Determination 2011/017

Refusal to issue a code compliance certificate for 3-year-old addition and alterations to a house at 18 Hodgkins Road, Pukehangi, Rotorua

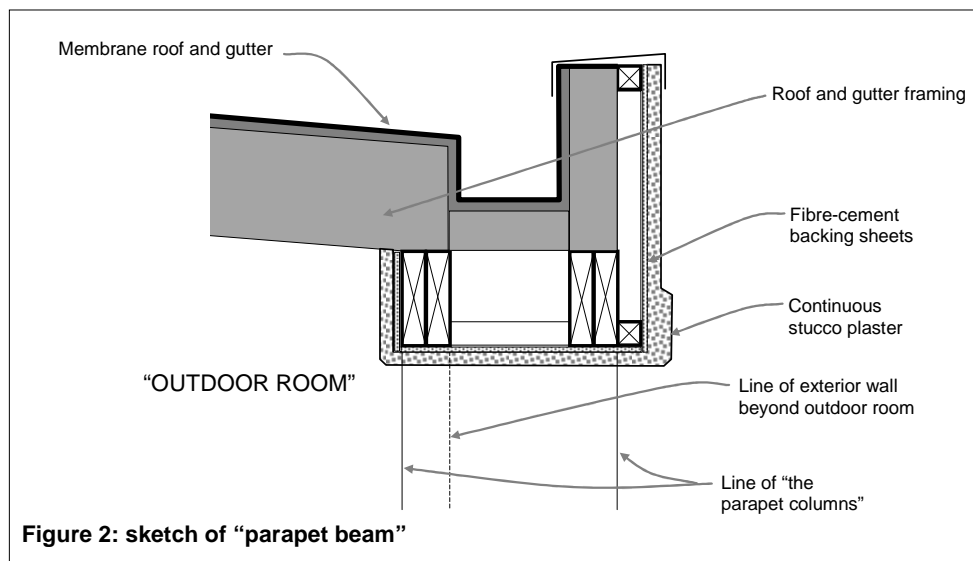
2.7.4 Based on the drawings and the builder’s description to the authority, the framed beams below the west addition parapet (“the parapet beams”) appear to be constructed approximately as shown in the following sketch:

2.7.5 As shown in Figure 2, the stucco extends from the outer face over the underside of the parapet beams between the parapet columns, with no drained cavity provided. The framed columns and parapet beam continue along the west elevation, around the recessed walls to the lounge and the master bedroom.

- the framed parapet beams lack any drainage to allow any moisture penetrating the cladding to escape to the outside (see Figure 2)
- the timber sample analysis taken from the bottom of the pergola column indicates that further investigation is required to establish the cause(s) for the moisture penetration and the fungal growth in the treated timber.

- 7.1 The authority should issue a notice to fix that requires the owners to bring the additions into compliance with the Building Code, identifying the defects and investigations listed in paragraph 5.5 and paragraph 6.3.2 and referring to any further defects that might be discovered in the course of investigation and rectification, but not specifying how those defects are to be fixed. It is not for the notice to fix to specify how the defects are to be remedied and the building brought to compliance with the Building Code. That is a matter for the owners to propose and for the authority to accept or reject.
